BACKGROUND INFORMATION

Electrical noise from EM transmission in 2Hz/2cycle in some applications can interfere with internal tool string communications, resulting in null toolfaces observed in operations. The issue has been reproduced in lab testing after multiple confirmed reports from the field.

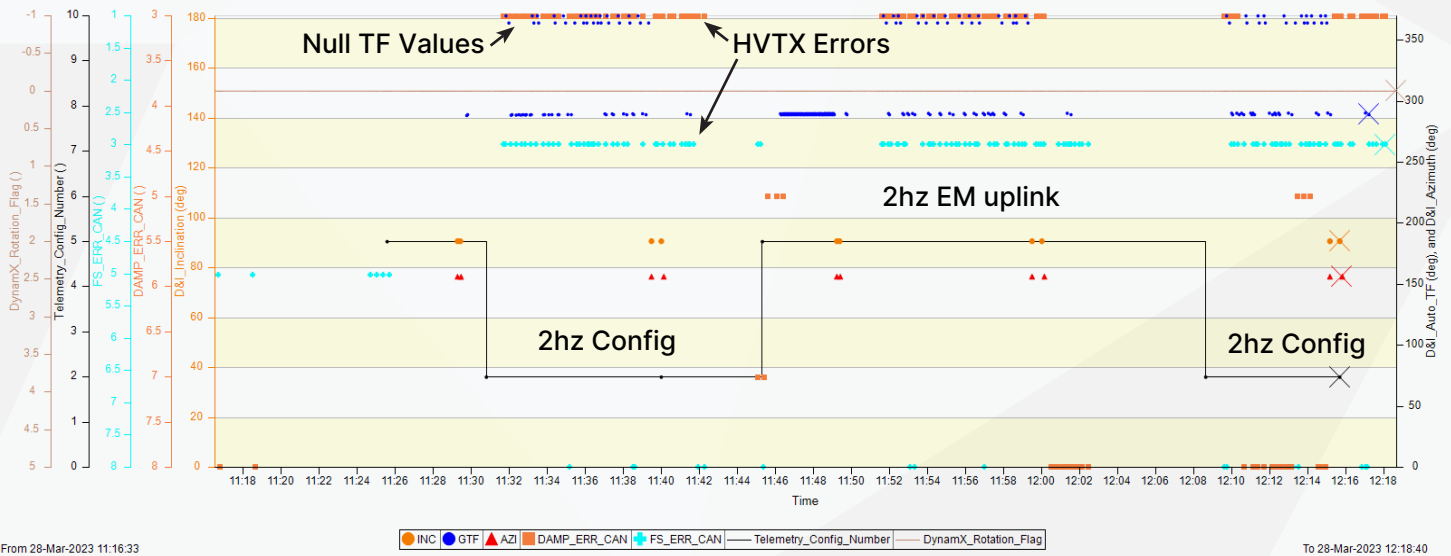
Below is logged data from one of the tests conducted to replicate the issue. Whenever the string was set to transmit in 2hz several HVTX errors would start to occur and tool faces would intermittently be sent and recorded as null values. These are seen as -8888 decodes on the surface gear and tool faces above 360° in the memory.

From 28-Mar-2023 11:16:33

To 28-Mar-2023 12:18:40

2 Hz configurations should be avoided for use in the field. 2.5Hz configurations have been proven to not cause the issues in bench testing and field use. The engineering team will continue to evaluate the situation and advise when and how 2 Hz configurations can safely be used in the future.
